SMEC Ref No: 30040611E

RE: Lendlease Submission relating to Amendment C232melt

The Toolern Precinct Structure Plan (PSP) and Development Contributions Plan (DCP) were first adopted by Melton City Council in 2010. Council has undertaken a review of the Toolern PSP and DCP and is proposing Amendment C232melt (The Amendment).

Figure 1: Proposed Infrastructure Items to be included in DCP (in yellow)

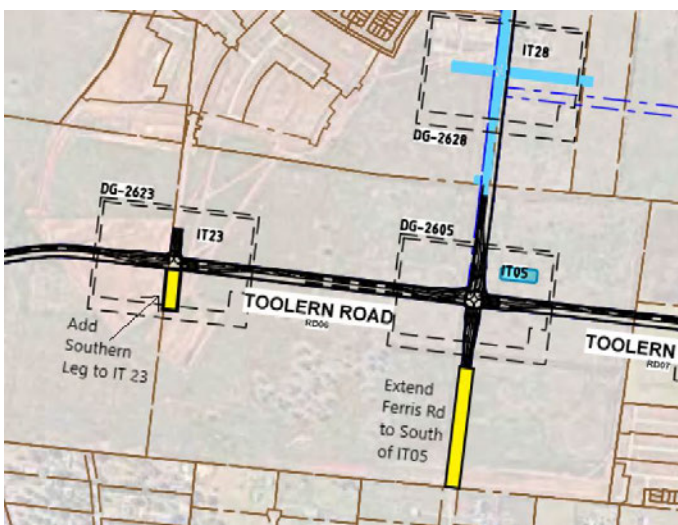
Lendlease also proposes that the scope of the Toolern PSP & DCP be increased to include the southern leg of IT23 (Figure 1)

- SMEC is of the opinion that, similar to IT21 and IT22, the Billeroy urban design and subsequent traffic volumes may warrant the inclusion of the southern leg of this intersection in the DCP scope.
- It is usual practice for DCP intersection projects to include the portion of road that is required within the development that is necessary for the signalised intersection to function as intended (including turn lanes, and detector loops that are a necessary part of the intersection works).

Lendlease proposes that the scope of The Amendment be increased in scope to include the extension of Ferris Rd south of IT05 to the southern boundary of the Toolern PSP (Figure 1).

- Similar to Mt Cottrell Road, the future full extent of Ferris Rd will continue south of IT05 through the Strathtulloh estate for approximately 2 kilometres to Greigs Road.
- Ferris Rd road will ultimately be a main thoroughfare for traffic travelling north / south and whilst possibly not accommodating the same traffic volumes as Mt Cottrell Rd, Ferris Rd will likely include volumes that warrant inclusion in the Toolern DCP.

Figure 3: Proposed Changes to Toolern PSP Drainage Reserve Alignment – Property ID #29

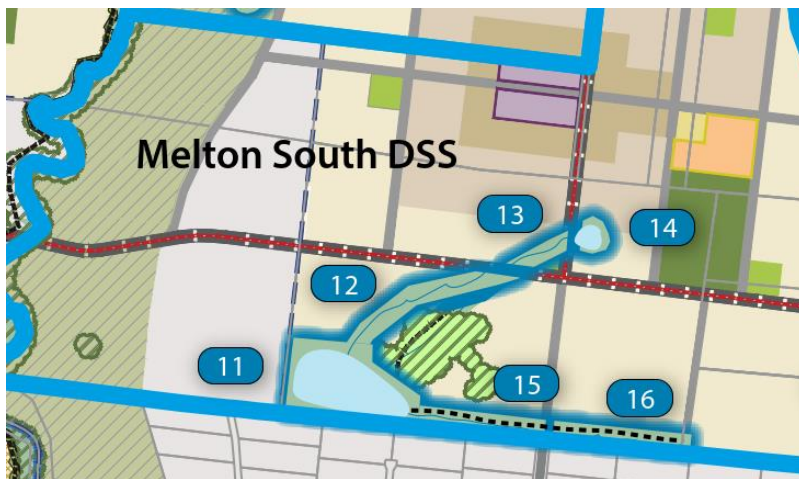
The alignment of the Melbourne Water Waterway Drainage Reserve from the basin in Atherstone Merevale Walk (Property ID # 29) to the Southern Wetlands is shown in The Amendment as running diagonally, south west through the future Billeroy precinct (Figure 2).

In addition, the location of the basin the Merevale Walk is currently shown as being offset north of the East-West Arterial Road, whilst in fact it should be shown as located directly adjacent to this road (Figure 3).

The Amendment should be updated to reflect the alignment of this Sed basin, drainage reserve and the Wetlands as previously agreed by Melton Council and Melbourne Water (Figure 3).
